1 & 2. Case ZON2004-01804

ZONING AMENDMENT STAFF REPORT Date: September 2, 2004

LOCATION 770 and 772 Sullivan Avenue

PROPOSED ZONING B-1, Buffer-Business

PLANNING COMMISSION VICINITY MAP - EXISTING ZONING

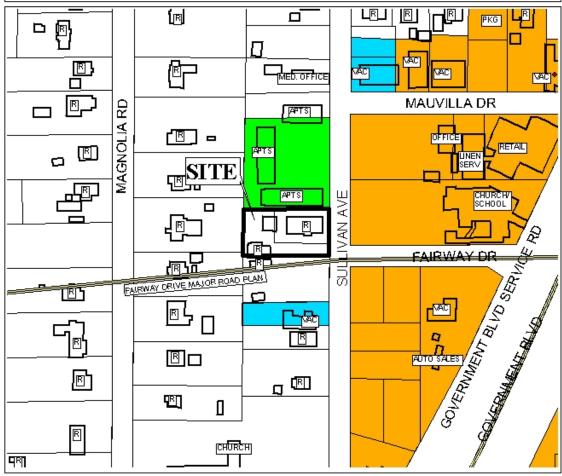
As illustrated on the Vicinity Map, the site would be impacted by the proposed extension of Fairway Drive, a planned major street. However, the dedication of right-of-way would require the removal of a portion of the residence on Lot 2, and all of the maneuvering area for the proposed parking stalls would be located in the right-of-way. It should also be noted that the site actually consists of two lots, thus Planned Unit Development (PUD) approval would be required for the shared parking and access; a PUD application was not submitted.

SITE PLAN

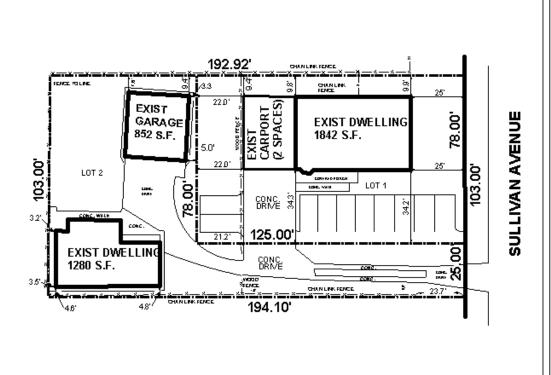
The site plan illustrates the two existing dwellings, garage, carport, proposed drive and parking. The facility will have eight to ten patients in residence as well as counseling services, and adequate parking is provided. However, in terms of access, the driveway width should be widened to 24-feet in width to allow adequate room for two-way traffic.

As with any rezoning, full compliance with the landscaping and tree planting requirements of the Ordinance would be required. Additionally, the provision of a buffer, in compliance with Section IV.D.1. will be required where the site adjoins residential zoning. It should also be noted that with the change in use, compliance with all applicable building codes will be required.

Rezoning: Based upon the preceding the application is recommended for approval subject to the following conditions: 1) widening of the driveway to 24-feet to accommodate two-way traffic; 2) full compliance with the landscaping and tree planting requirements of the Ordinance; 3) provision of a buffer, in compliance with Section IV.D.1. where the site adjoins residential zoning; 4) full compliance with all applicable building codes; and 5) full compliance with all municipal codes and ordinances.

Planned Unit Development: Based upon the preceding the application is recommended for approval subject to the following conditions: 1) widening of the driveway to 24-feet to accommodate two-way traffic; 2) full compliance with the landscaping and tree planting requirements of the Ordinance; 3) provision of a buffer, in compliance with Section IV.D.1. where the site adjoins residential zoning; 4) full compliance with all applicable building codes; and 5) full compliance with all municipal codes and ordinances.
